Pursuant to the provision of Schedule VI, Chapter XI Rule 2 (1) of the City of Karachi Municipal Act 1933, I hereby give you notice that I intend within the meaning of that rule to erect or re-erect/make additions & alterations to building on plot No. 13, Survey sheet GK 5 Situated in m.m. street G.K Quarter m.m. as per Ground plan, Elevation and Section sent herewith in quadruplicate.

PLAN SHOWING REGULARIZING UNAUTHORIZED WORK

Reference No. L. C. P. 127/40.

# PLAN SHOWING REGULARIZING UNAUTHORIZED WORK

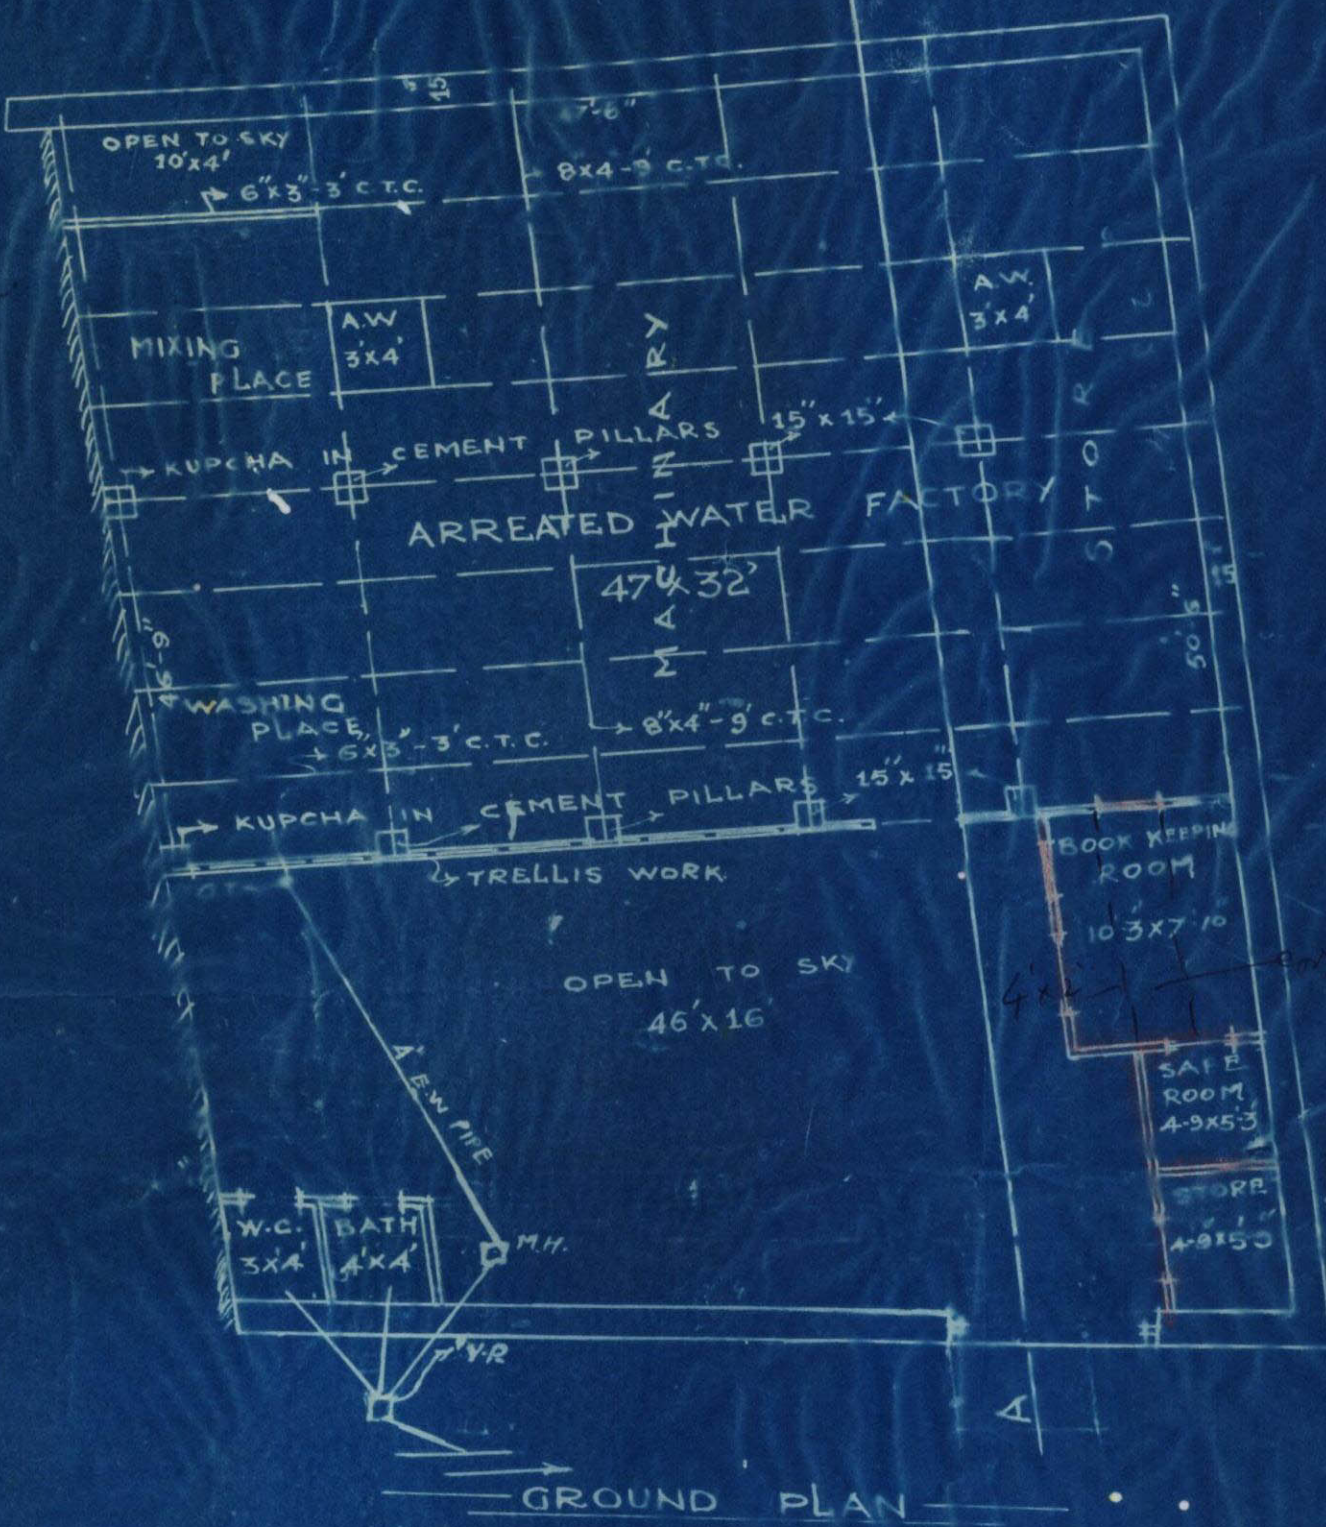
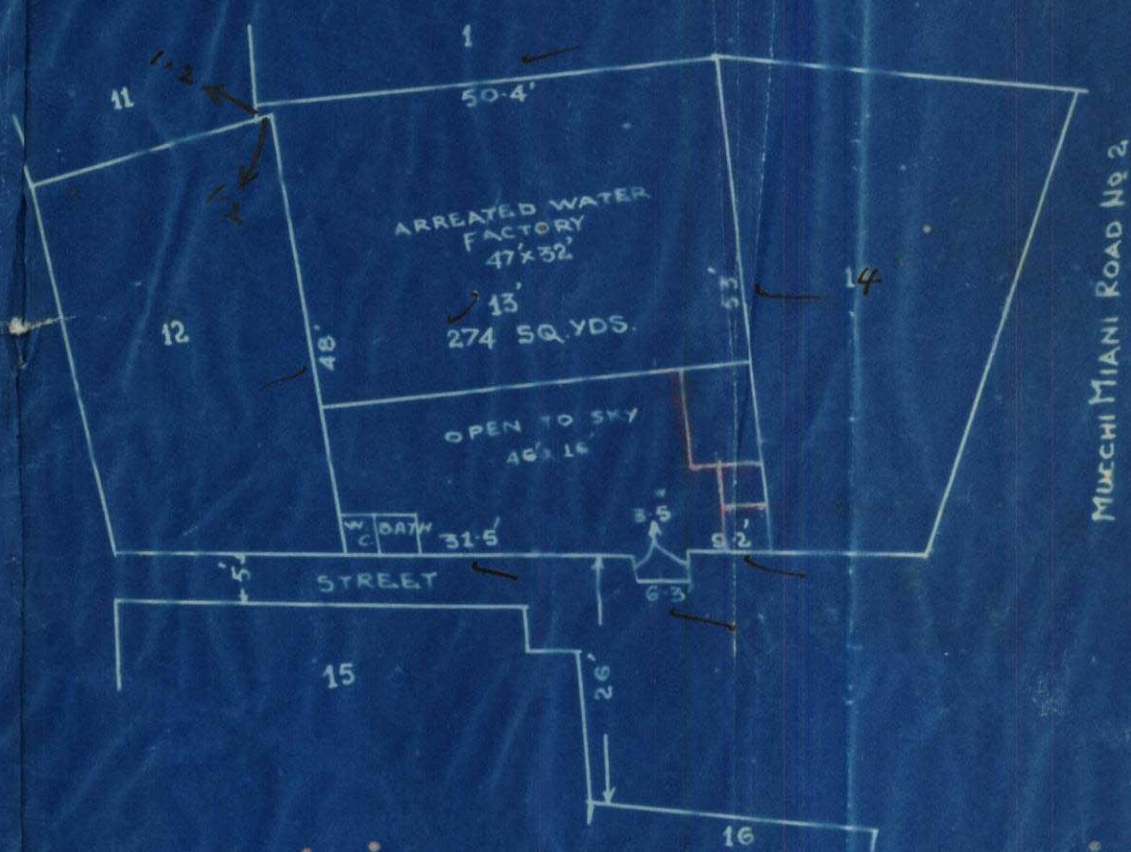
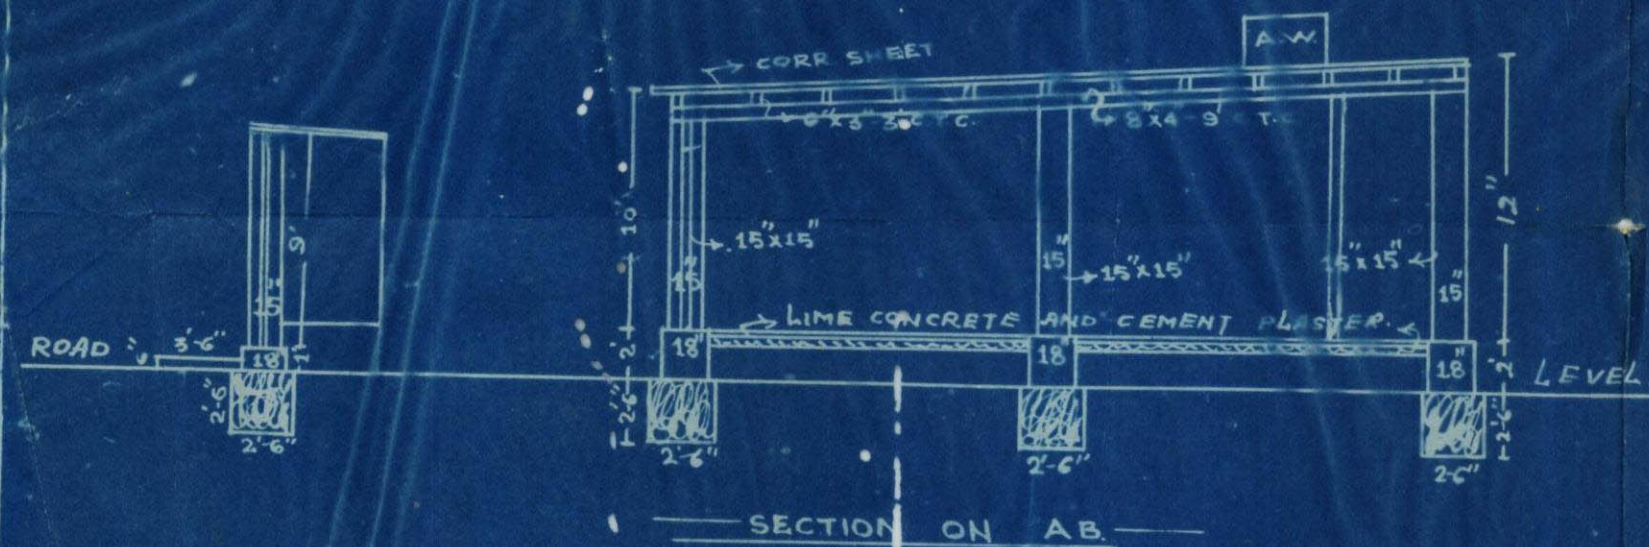
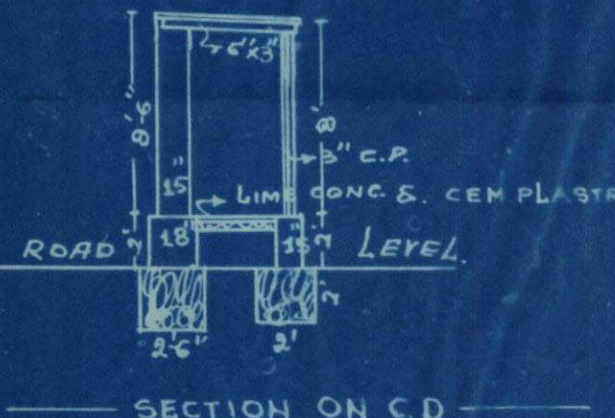
Complete Site measurements be given complete

- (2) Plinth of the rooms constructed unauthorisedly  
is less than 2 feet. The same must be made 2 feet  
high on site.
- (3) Height of rooms shall be at least 10 feet.
- (4) Book keeping room is being used as an office as  
such the same cannot be allowed because it has no  
through ventilation; proper plinth ~~xxx~~ is less  
than 100 sq. feet.
- (5) Details of roof for the unauthorised construction  
be given.

It is 1'-6" and  
since it is being used  
for storing records etc  
no objection  
It is 10 ft high

This is discontinued  
The statement of the  
architect is verified  
on site & found correct.

Complied  
28/5

Complete measurements  
as were sanctioned in the original  
approved plans are given.

(2) The floor of room which is  
not a living room is more than  
1' from main Mianee Road. It is  
not necessary to make 2'-0" beside  
my Court Yard is cemented and  
there is no likelihood of rain water  
going in the room.

(3) The height of room is 10'-0"

(4) Book keeping room is made  
a record room and there is  
a thala by the left side of gate  
which is being used as office  
and there are creepers on this  
thala.

5. Details of Corrugated roof  
gives that there are 4 x 2 rafters  
your  
Devkishindas
